Re: 5/10/22 meeting agenda ttem 4.8 -- Eminent domain, Shoreline Boulevard, Project 18-47

# SHORELINE BOULEVARD MIDDLEFIELD – TERRA BELLA EAST SIDE SUNDAY 5/8/22 P.M.

# SHORELINE BOULEVARD

NE Corner , Shoreline @ Middlefield

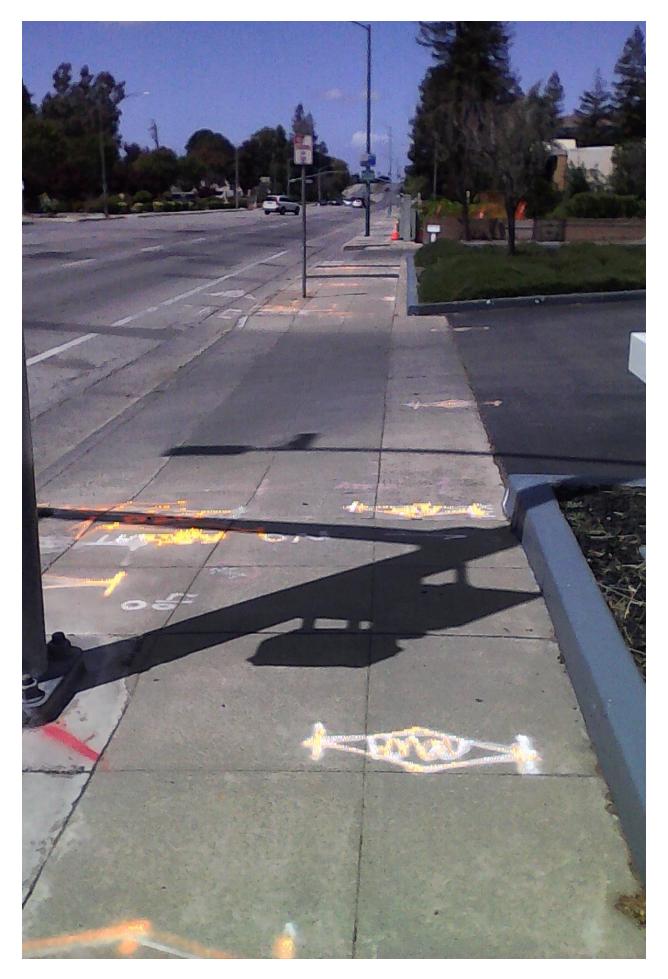
One ramp serves two crosswalks, neither aligned with ramp, forcing anyone using a wheeled device into the path of turning vehicles. Crosswalk paint almost worn out.

Shell north driveway

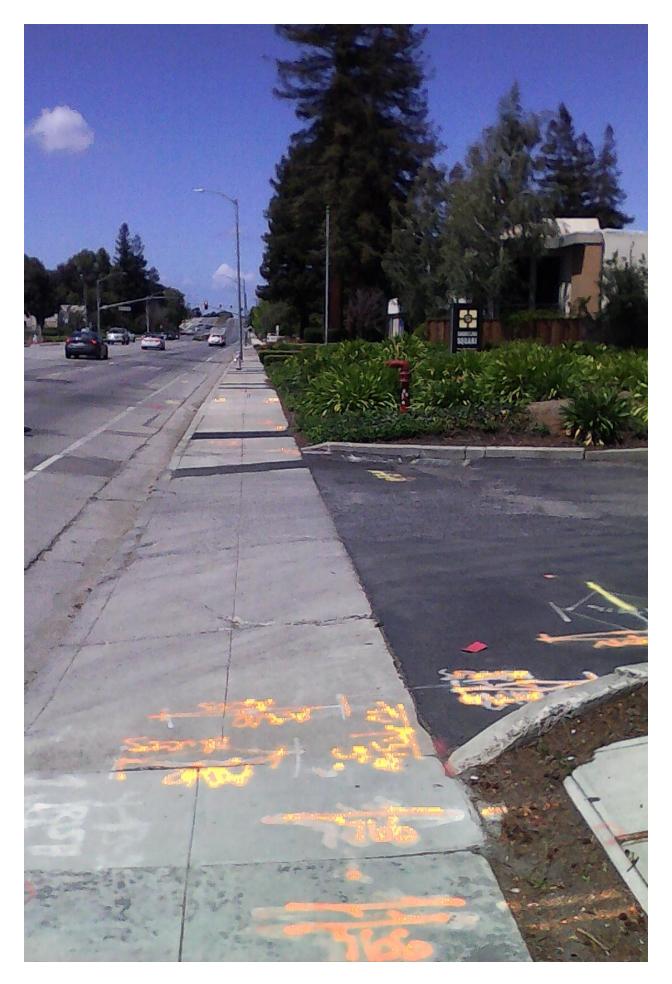
Another good place to get run over.

Between Shell station and Shoreline Square Sidewalk narrows to ~6'. Excavation, vault, utility boxes. signpost obstruct walkers.

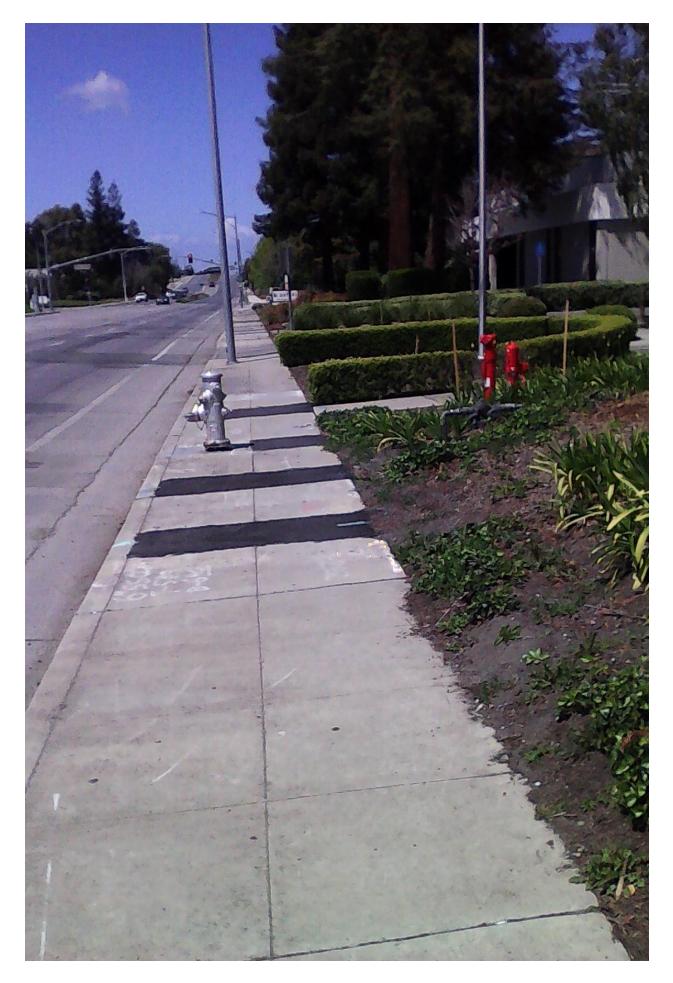
Shoreline Square driveway. One more good place to get run over. Sidewalk ~6', not level, no setback.

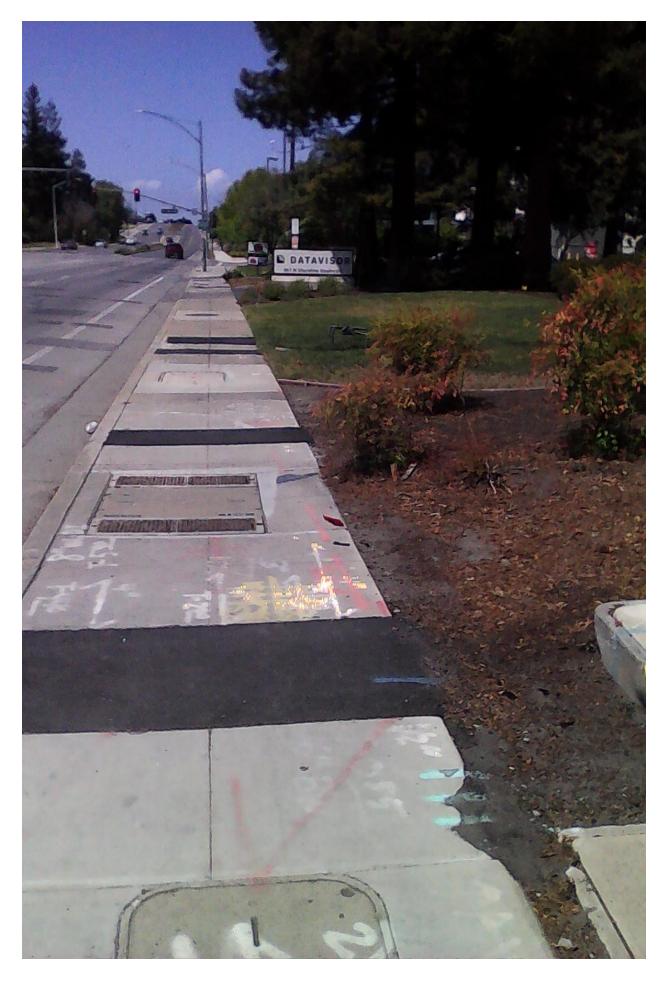
Outside Shoreline Square, former home of two tall redwoods needlessly sacrificed. Sidewalk ~6', half obstructed, no setback.

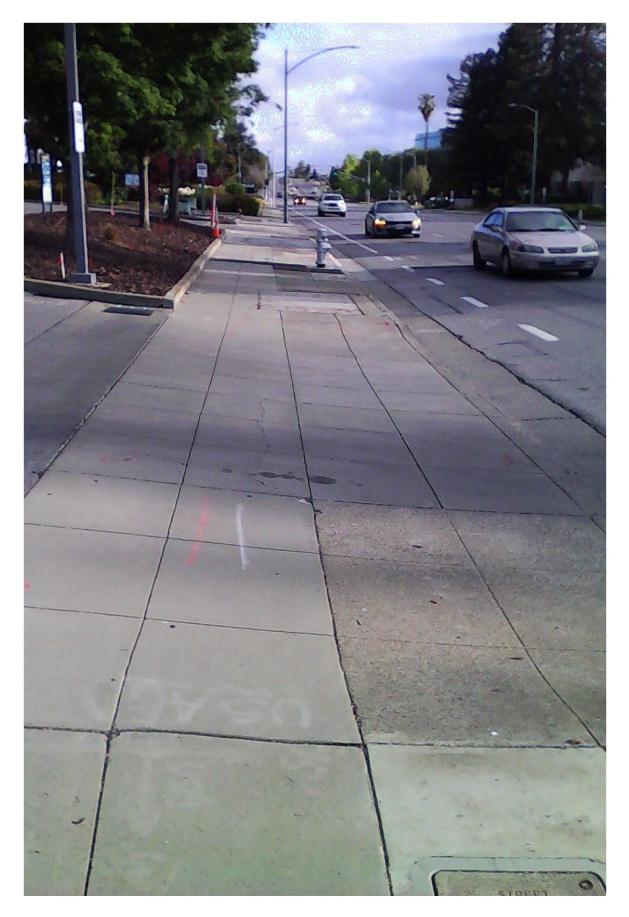
NW corner Shoreline @ Middlefield outside Chevron station. Utility box obstructs pedestrians' and drivers' views

Chevron station south driveway Good place to get run over by driver anxious to exit station

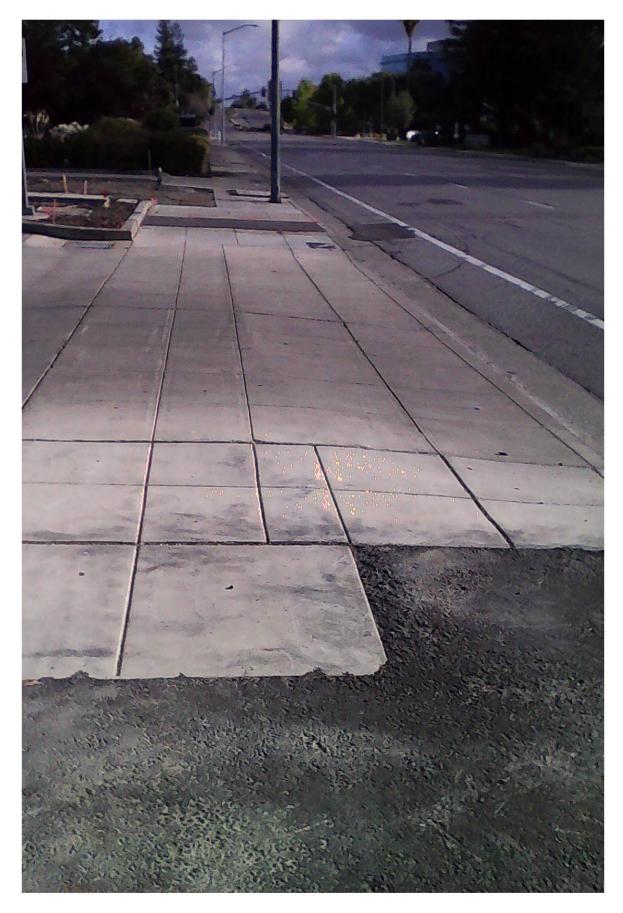
Outside Chevron station -- Sidewalk 4 slabs wide so hydrant doesn't get in pedestrians' way. No setback from street.

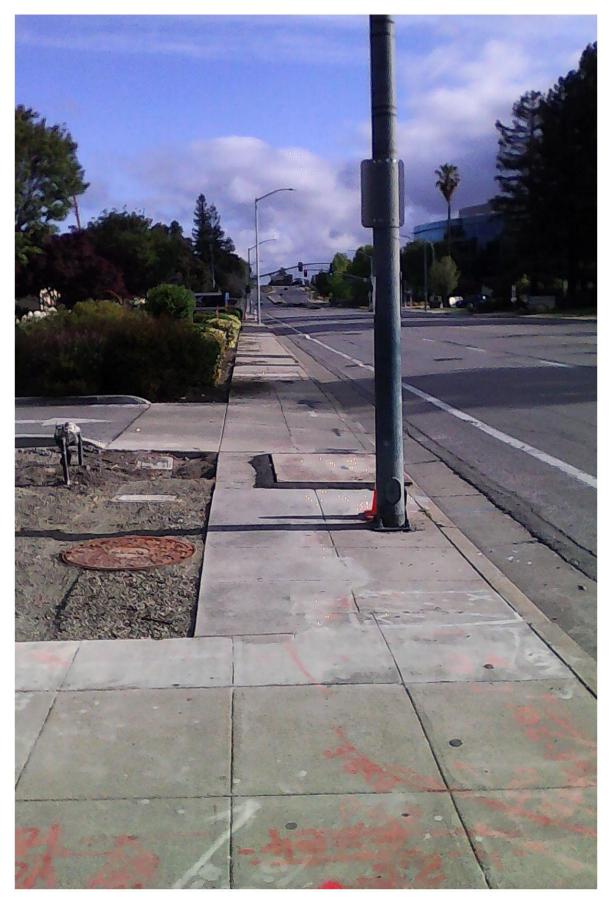
Chevron station north driveway Another good place to get run over by vehicles exiting station

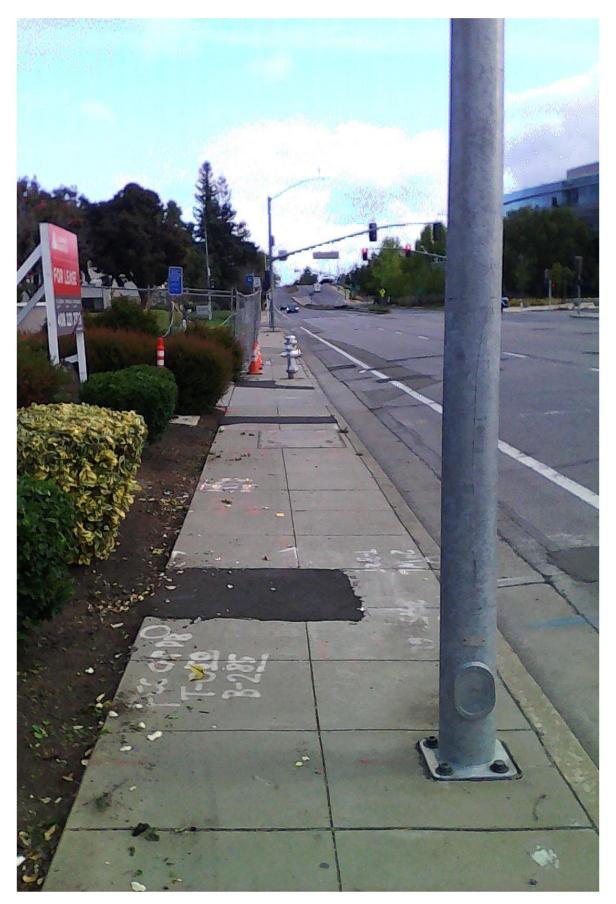
850 Shoreline -- Sidewalk narrows to 6', including curb; no setback. Pole obstructs pedestrians. Shrubbery obstructs view of drivers exiting property. Covering of recent excavation creates tripping hazard.

Approaching 1215 Terra Bella.

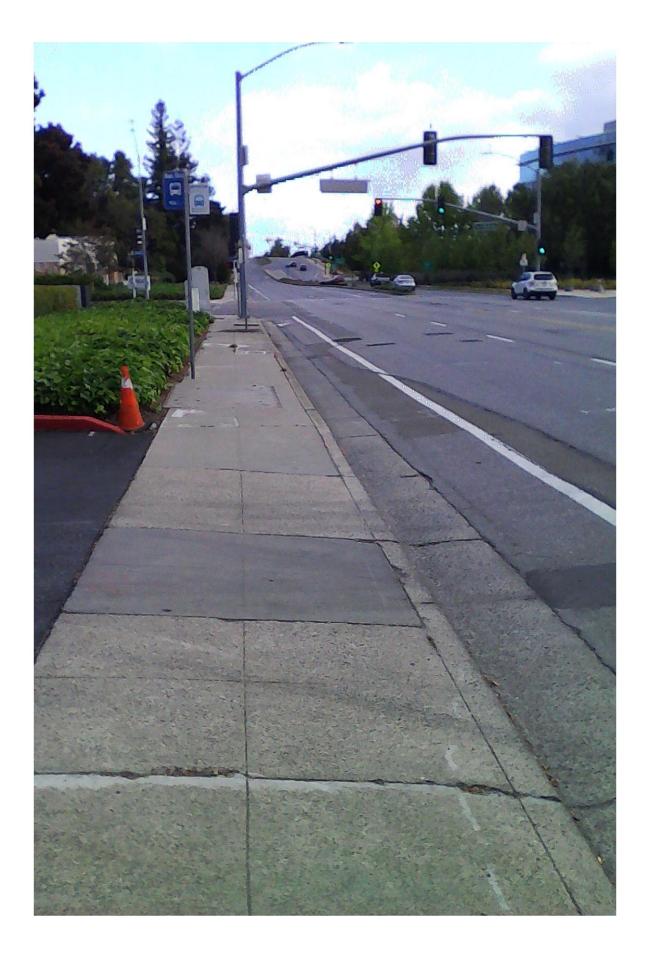
6' sidewalk, no setback. Hydrant, cones and fencing around open excavation obstruct pedestrians. Views from driveway also bad,

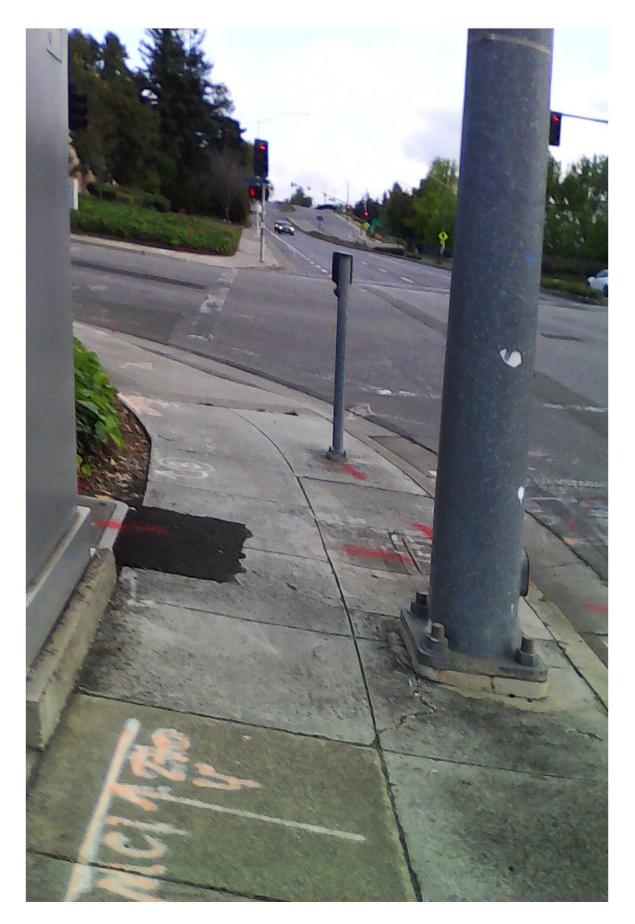
1215 Terra Bella driveway -- 6' sidewalk, no setback. Good place to get run over.
